ORDINANCE NO. 525

AN ORDINANCE OF THE CITY OF BURIEN, WASHINGTON, CONCURRING WITH CITY OF BURIEN'S PRELIMINARY APPROVAL AND RECOMMENDATION FOR FINAL APPROVAL, SUBJECT TO CONDITIONS, OF THE SUBDIVISION KNOWN AS DES MOINES ESTATES.

FILE NO: LU 03-0217A

**TYPE 3 LAND USE REVIEW
STAFF RECOMMENDATION TO THE HEARING EXAMINER**

DESIGNER: MEDINA CONSULTING ENGINEERS, INC.
 PROJECT: DES MOINES ESTATE PLAT
 SHEET: 1118100
 DATE: 11/18/00
 DRAWN BY: J. H. HARRIS
 CHECKED BY: J. H. HARRIS
 APPROVED BY: J. H. HARRIS

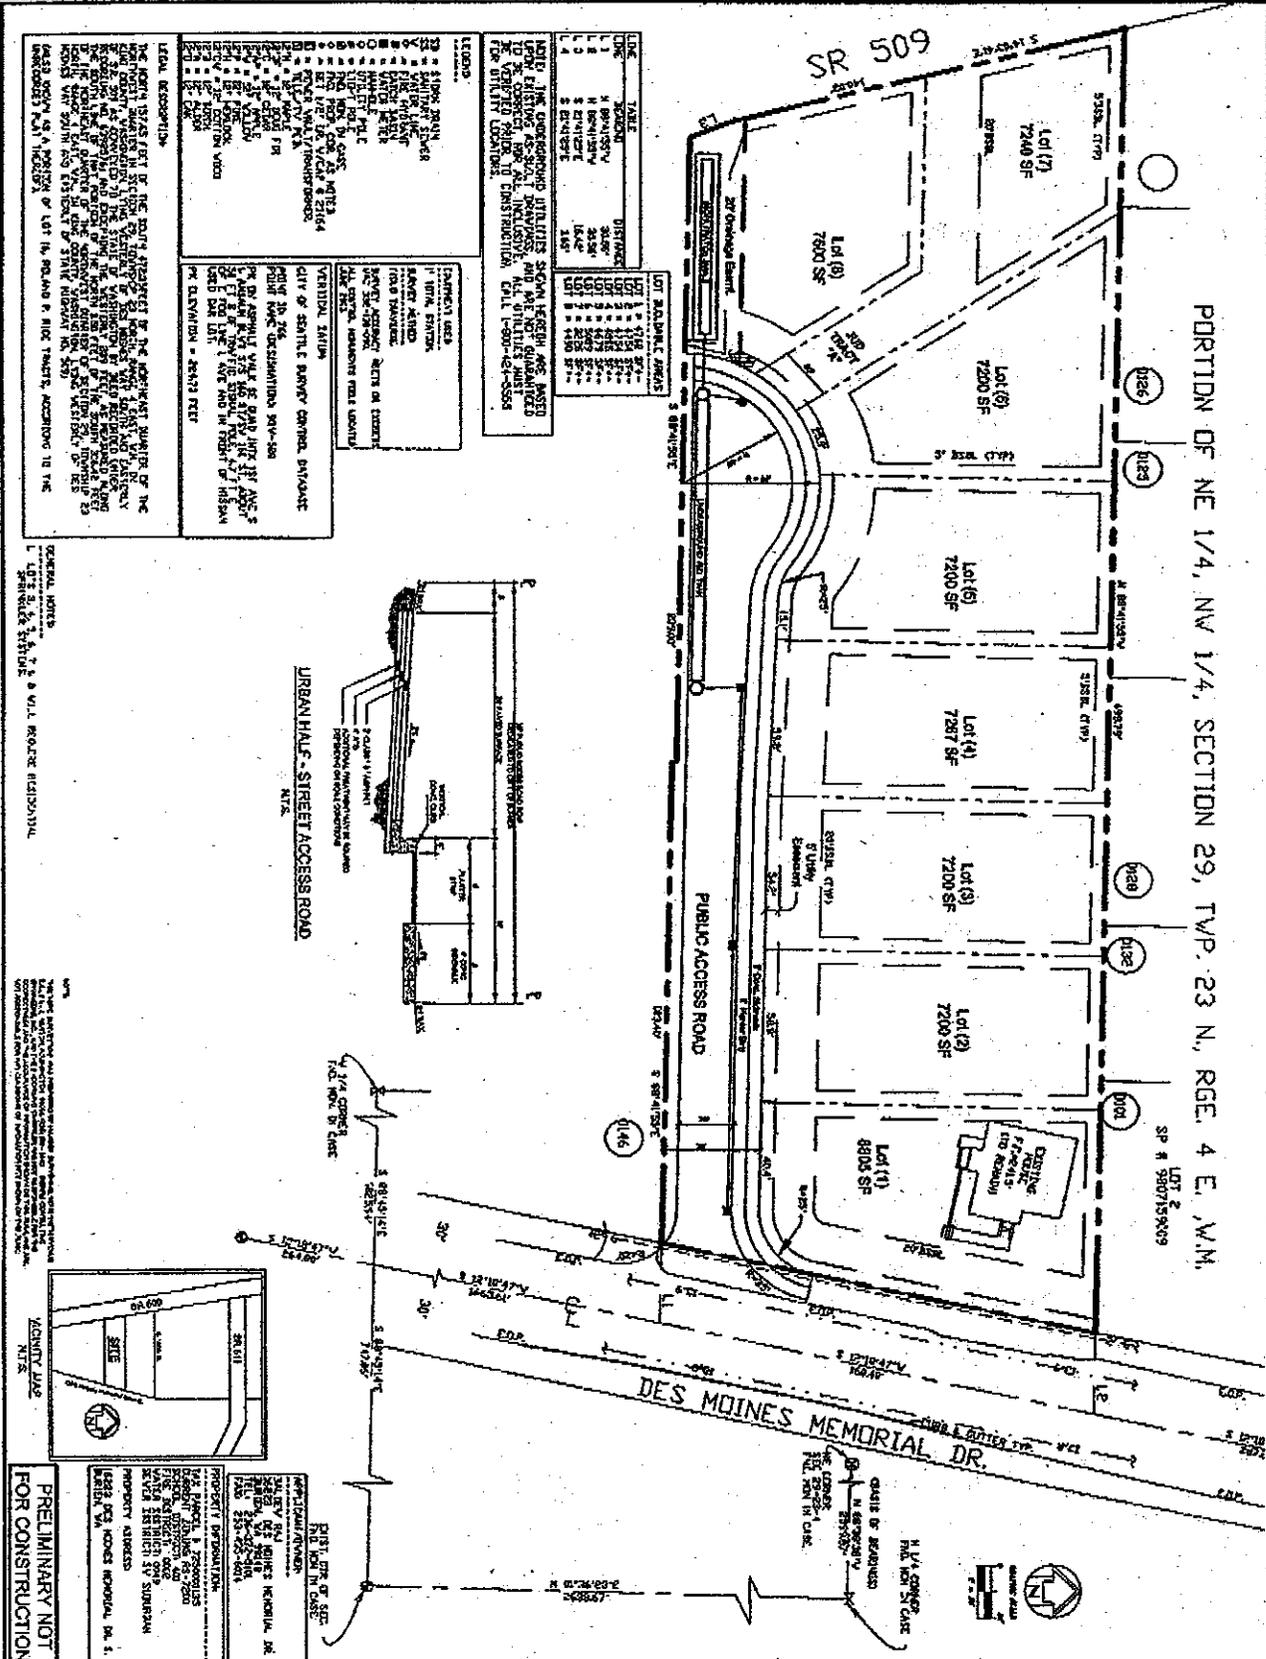
1. Much of the data in the lower left and right corners is redundant, as it is already included on Sheet C1.

2. The access road will require a station line, advancing easterly and a profile.
3. Reference KCRS Dwg. No. 3-002 for the curb/gutter and sidewalk details.
4. The curb return at the intersection with Des Moines Memorial Dr. S will require an ADA ramp meeting current standards.
5. Clearly show existing utilities within Des Moines Memorial Dr. S and the proposed locations on the access street.
6. Des Moines Memorial Dr. S is in the jurisdiction of the City of SeaTac. What frontage improvements, if any, will be required by that City? Please provide a letter, with the next submittal, from the SeaTac Public Works Department.

1. See comment 1 above.
2. The drainage system could be included on Sheet C1 of 3.
3. A profile of the storm drain system will be required along with design details for the underground D/R tank, manholes CBs and pipe.

7. The recommended Interceptor Drain System, along the north and part of the south side of the property, will have to be included in the plans. See Conclusions and Recommendations, "Subsurface Exploration and Surficial Hydrologic Study" by Associated Earth Sciences, Inc., October 17, 1989, pages 6 and 7.

8. An erosion control plan will be needed for the road grading.
